PCN-20210510 KK0803-03A to KK0803-04 Hardware Revision Change

Company	Trenz Electronic GmbH
PCN Number	PCN-20210510
Title	KK0803-03A to KK0803-04 Hardware Revision Change
Subject	Hardware Revision Change
Issue Date	2021-05-14

#1 Changed milled height profile.

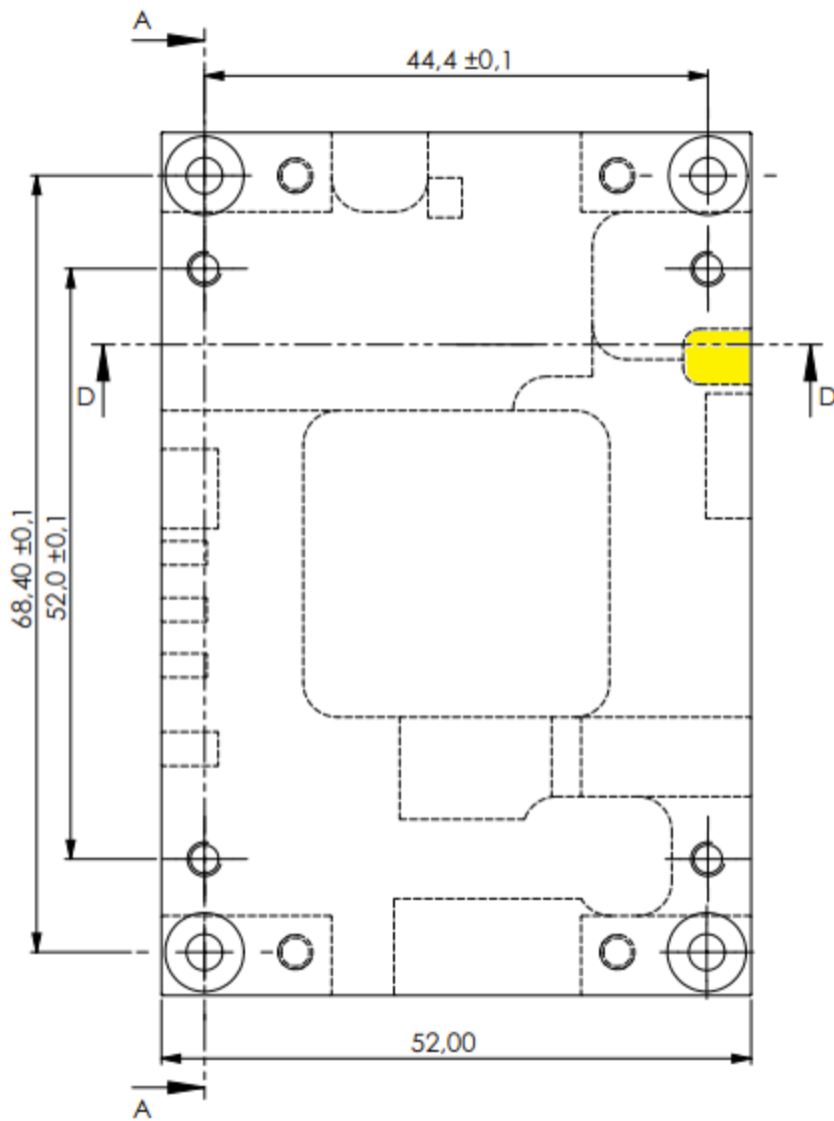
Reason: Revision 04 of TE0803 has different skyline and is therefore mechanical not compatible with KK0803-03A.

Impact: New heat spreader is compatible with TE0803-04, and also backwards compatible to older versions of TE0803.

Models with the feature marked in yellow are revision 04. Heatspreader without that feature are of older revision and not compatible to TE0803-04.
